SYSTEM/MODEL: TD-H/B

MODIFICATION: LED call indicator in place of call tone

REFERENCE DRAWING #: 1298-1065

CALL INDICATION LED FOR TD-H MASTERS

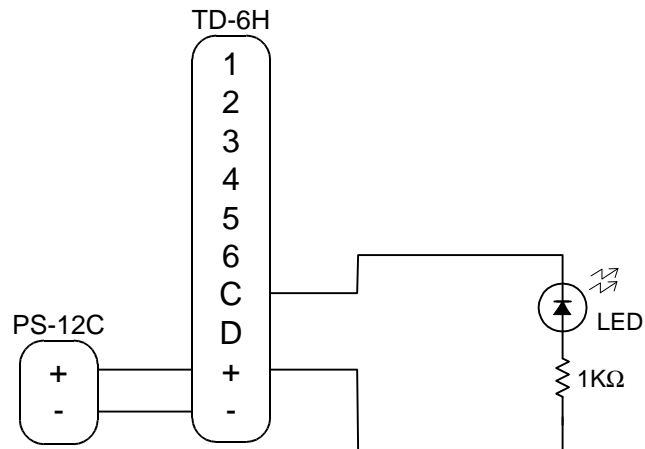
1. To eliminate the call tone, remove diode D3 from the main PC board.
2. Install the general purpose LED and 1KΩ resistor as shown above. As there is no designated location for placement of the LED, either modify the chassis of the master station or mount the LED externally.
